### **Authors' responses to the editor's comment:**

### **Authors' responses to the reviewer's comments:**

## ***Reviewer # 1***

Figure 1: Convergence test done for (i) temperature from 300 K to 83 K by step of 20 K and (ii) capture cross section ( $\sigma_n \rightarrow 0$ ) from  $1 \times 10^{-16} \text{ cm}^2$  to  $1 \times 10^{-31} \text{ cm}^2$  by step of  $10^{-3}$ .

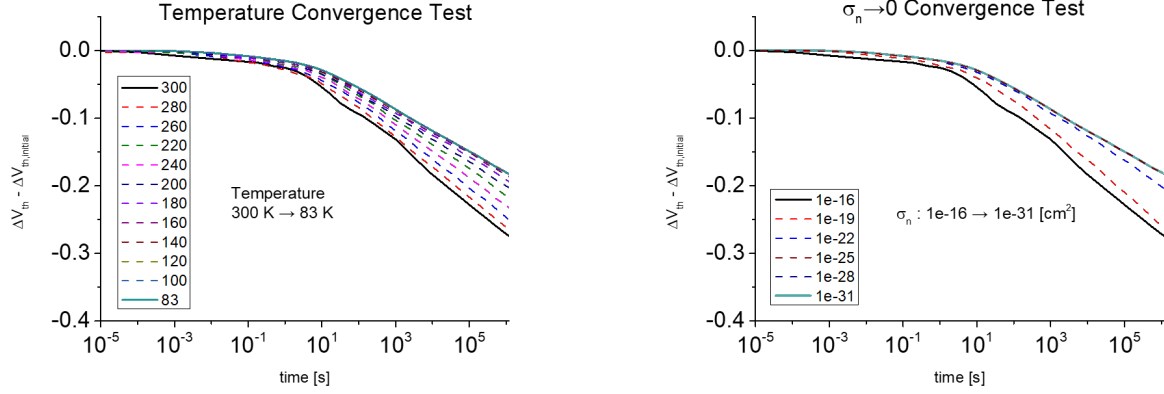
The manuscript states that direct TCAD simulation at 4.2K did not converge and that the electron capture cross section was therefore reduced to an extremely low value during retention to emulate cryogenic operation. However, lowering the temperature to 4.2K should affect not only the capture cross-section but also carrier distribution, fermi occupation, thermal velocity, emission/capture balance, and field-assisted transport parameters. Could the authors justify why only reducing  $\sigma_n$  is sufficient to represent cryogenic retention? If the change in other parameters was also included, please adequately explain it. Please also provide a sensitivity analysis showing whether the retention transient saturates as  $\sigma_n$  is reduced.

We thank the reviewer for this important comment. We agree that reducing only  $\sigma_n$  does not reproduce all temperature-dependent physical quantities at 4.2 K, such as carrier statistics, thermal velocity, Fermi occupation, emission/capture balance, and field-assisted transport parameters. Therefore, in the revised manuscript, the reduced- $\sigma_n$  condition is clarified as a cryogenic-emulation benchmark for suppressing thermally activated trap-to-conduction-band transitions, rather than as a full direct TCAD simulation at 4.2 K. To justify this treatment, we performed two independent convergence tests: (i) a temperature-lowering test and (ii)  $\sigma_n$ -lowering test.

In the temperature-lowering test, the TCAD temperature was reduced from 300 K to 83 K, which was the lowest temperature at which stable convergence was obtained in our setup. In the  $\sigma_n$ -lowering test,  $\sigma_n$  was reduced from  $10^{-16}$  to  $10^{-31}$  cm<sup>2</sup> in three-decade steps. As shown in response Figure 1, the retention transient converged to a limiting curve as  $\sigma_n$  was reduced, confirming that the selected low- $\sigma_n$  condition is not an arbitrary fitting point.

The low- $\sigma_n$  limiting curve also showed the same retention-time tendency as the independently obtained temperature-lowering trend. These results indicate that suppressing thermally activated trap transitions by reducing  $\sigma_n$  can reproduce the dominant cryogenic detrapping tendency within the convergent TCAD

framework. Accordingly, all TCAD results in Fig. 3 of the revised manuscript are described as calibrated cryogenic-emulation benchmarks, not as direct full-physics 4.2 K TCAD simulations.

Fig. 3(c): Comparison between the time-step-free simulation and the iterative refresh test for assessing the fixed-emission-rate approximation.

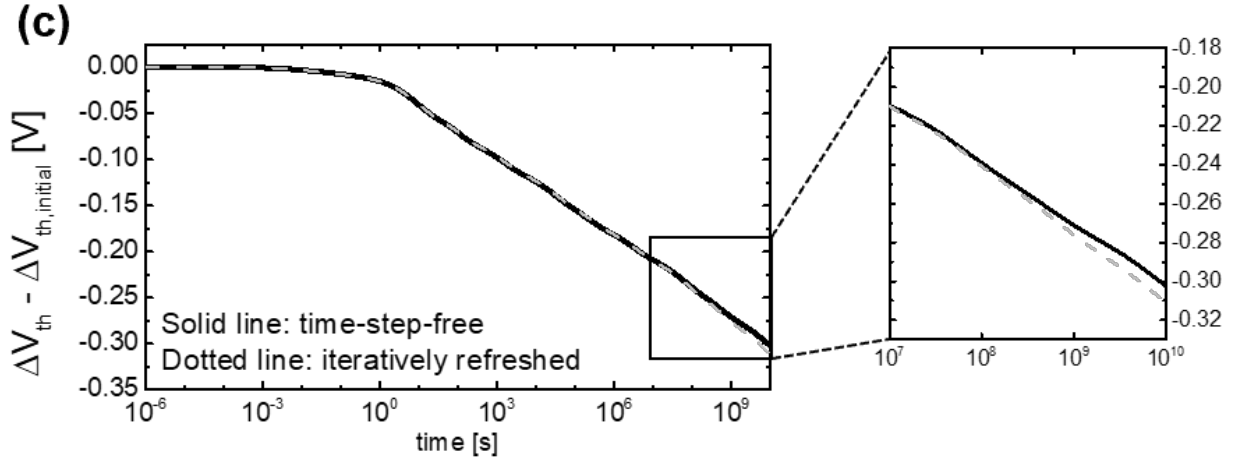
Does the time-step-free solution assume that  $e_{ch}$  and  $e_{WL}$  remain constant during retention? Considering that the trapped charge density, local potential,  $e$ -field, and tunneling barrier profile may change as

trapped electrons are emitted, emission rates can be modified. Could the authors provide a more detailed explanation and physical justification for treating the emission rates?

We thank the reviewer for raising this important modeling assumption. Yes, in the proposed time-step-free solution,  $e_{ch}$  and  $e_{WL}$  are evaluated from the initially programmed trapped-charge distribution and are treated as fixed during one closed-form retention evaluation. This fixed-emission-rate approximation makes the local detrapping equation autonomous and enables the closed-form solution in Eq. (13).

We agree that, in a fully self-consistent transient calculation, trapped-charge loss can modify the local potential, electric field, and tunneling barrier profile, and thus the emission rates can also be modified. To examine the error introduced by this approximation, we added Fig. 3(c), which compares the proposed time-step-free simulation with an iterative refresh test. In the iterative refresh test, the trapped-charge distribution is sequentially updated after each retention interval and then used as the initial condition for the next interval. Therefore, the refresh test partially accounts for the change in the electrostatic/barrier condition caused by the emitted charge.

As shown in Fig. 3(c), the time-step-free simulation and the iteratively refreshed simulation show nearly identical  $\Delta V_T$  behavior over the retention range, with only about 3% difference appearing after times exceeding  $10^9$  s. This result indicates that the fixed-emission-rate approximation introduces only a minor error for the cryogenic radial detrapping benchmark considered in this work. Therefore, the non-iterative time-step-free simulation was selected as the main method because the iterative refresh test simply multiplies the simulation time by the total number of refresh iterations while producing almost the same retention result.

Figure 2: Convergence test done for (i) total trap bin # and (ii) CTN slice # showing good tendency of convergence from trap bin at 100 layers and CTN at 30 slices.

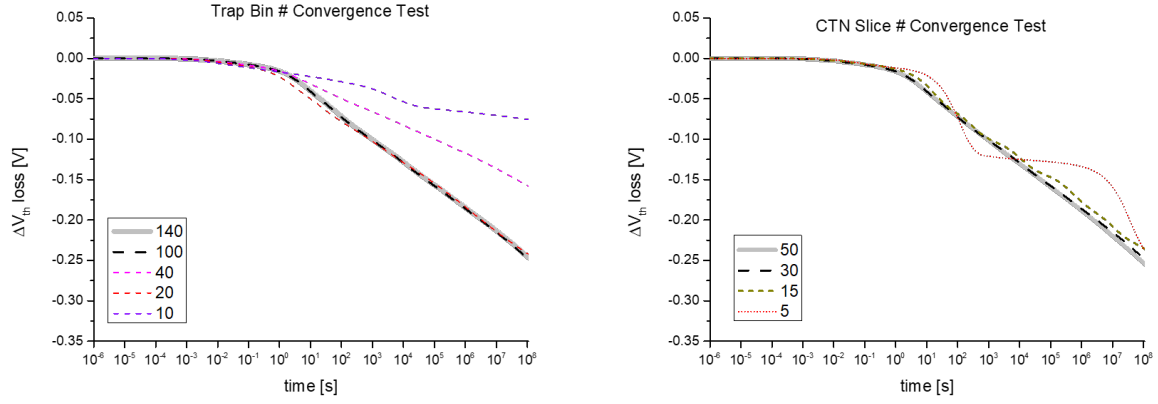
The model uses 100 trap-energy bins and 30 radial CTN slices. Could the authors provide a convergence test with respect to the number of energy bins and radial slices? Since the emission rate depends exponentially on trap energy and tunneling barrier shape, the predicted retention transient may be sensitive to discretization resolution.

We thank the reviewer for this constructive comment. We agree that discretization convergence should be checked because the emission rate depends sensitively on trap energy and tunneling barrier shape. We therefore performed convergence tests with respect to both the number of trap-energy bins and the number of radial CTN slices.

As shown in the additional convergence Figure 2 prepared for this response, the predicted retention transient becomes stable as the energy and radial discretization are refined. The result obtained with 100 trap-energy bins and 30 radial CTN slices is already in the converged regime for the benchmark condition

considered in this work. Further refinement produces negligible change in the retention transient while increasing the computational cost. Therefore, 100 energy bins and 30 radial CTN slices were selected as a numerically converged and computationally efficient discretization.

We revised the manuscript to state the discretization used in the model were confirmed to be in converged regime.
